Drawing Change Notice

CHANGE DOCUMENT NO.
24590-PTF-MVN-PJV-00005

JOB NO. 24590	TITLE FOR CHANGE NOTICE Addition of 3" diameter Purex Connector as Vacuum Breaker	ISSUED BY RPP-WTP PDC	 R11003709
------------------	--	--------------------------	--

DESIGN DOCUMENT NUMBER 24590-PTF-MV-PJV-00002001	REV NO 0	TITLE OF DESIGN DOCUMENT EQUIPMENT ASSEMBLY, PTF DEMISTER VESSEL, PJV-DMST-00002A/B/C, SHEET 1 OF 2
---	-------------	--

- Add the following Purex nozzle detail:

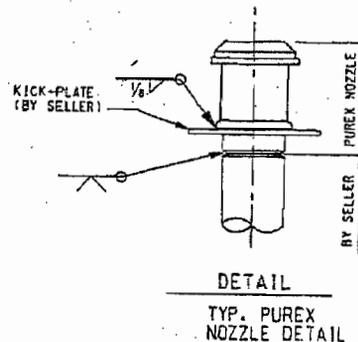
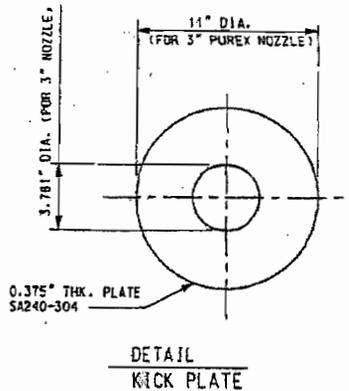
- Add 3" diameter Sched 80S nozzle, 3" dia. Purex connector, and kickplate at top dead center of vessel head in Zones D - 7 and G - 7. Deadweights of the 3" Vertical Blank Assembly (see BNI Dwg 24590-WTP-P61-P27T-00010 Rev. 0) and 3" Connector Block (see BNI Dwg 24590-WTP-M61-P23T-00016 Rev. 2, Piece 1) shall be used to analyze nozzle stress.

- Add Note 21: 3" DIAMETER MALE PUREX CONNECTORS PER BNI DWG 24590-WTP-M61-P23T-00005 REV. 3 SHALL BE PROVIDED TO SELLER FOR N03. THE INSTALLATION OF THE PUREX CONNECTORS TO THE PIPE NOZZLES AND SUPPLY AND INSTALLATION OF THE KICK PLATES IS INCLUDED IN SELLER'S SCOPE OF WORK. NOZZLE N03 SHALL BE USED WITH ITEM 1 ON BNI DWG 24590-WTP-M61-P23T-00016 REV. 2 & THE 3" VERTICAL BLANK JUMPER ASSEMBLY ON BNI DWG 24590-WTP-P61-P27T-00010 REV. 0 WHICH ARE SHOWN FOR DIMENSIONAL GUIDANCE ONLY (THESE ITEMS WILL NOT BE SENT TO SELLER) WITH OVERALL DIMENSIONS SHOWN ON BNI DWG 24590-WTP-P61-P27T-00094 REV. 0. THE PROJECTED END OF THE PUREX CONNECTOR SHALL EXTEND 11" ABOVE THE CROWN OF THE TOP HEAD. SEE BNI SPEC #24590-WTP-3PS-MV00-T0001 FOR N03 NOZZLE LOADS.
